BOSTON EDISON COMPANY
300 BOYLSTON STREET
BOSTON, MASSACHUSETTS 02199

June 28, 1984
BECO. 84-095

License No. DPR-35
Docket No. 50-293

On May 2, 1984, a telephone conference took place regarding the Pilgrim Nuclear Power Station Inservice Inspection Program. Participants at this meeting were P. Leech from the NRC; G. Freund and R. Yorg from EG&G; and F. Famulari, T. Ferris, and M. Williams from Boston Edison Company. Eleven items were discussed, in which resolution was reached on NRC Items 1, 2, and 3. This letter provides information for resolution of the remaining items (4-11).

E-232-336

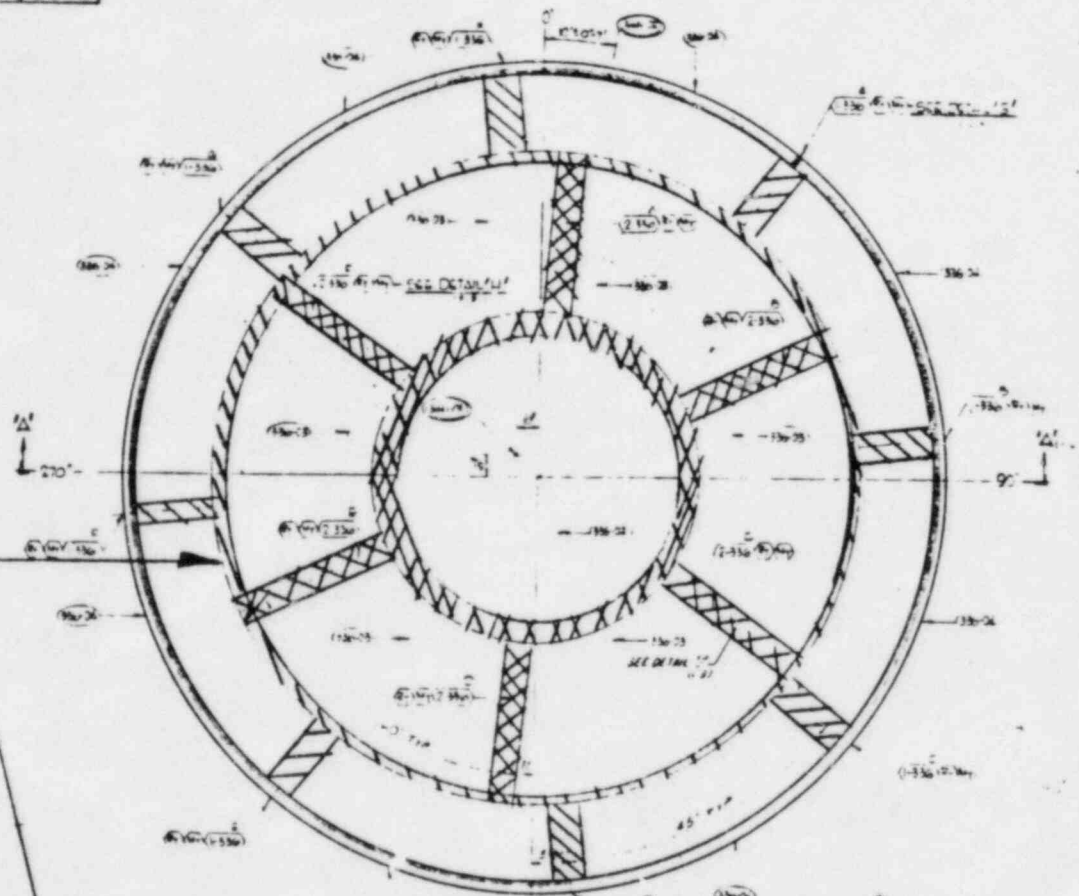
Item B1.21 and B1.22 of Category B-A (PRR-5) require that the accessible portions up to 100% of one head weld in each direction be examined. It appears that your program meets code requirements for examining head welds. Please state why you believe that relief is needed.

WE CAN ONLY
PERFORM A ONE
SIDED EXAM DUE
TO THE VESSEL
SKIRT

The reactor vessel bottom head meridional welds are accessible for ultrasonic examination. However, the configuration of the reactor vessel bottom head and vessel support skirt limits the examination of the outer circumferential weld to a one side only examination. See Attachments 5 and 6 for drawings depicting the accessible welds and the restrictions. Approximately sixty percent of the length of the reactor vessel bottom head welds is accessible for examination. Revised Relief Request No. PRR-5 is submitted as Attachment 7.
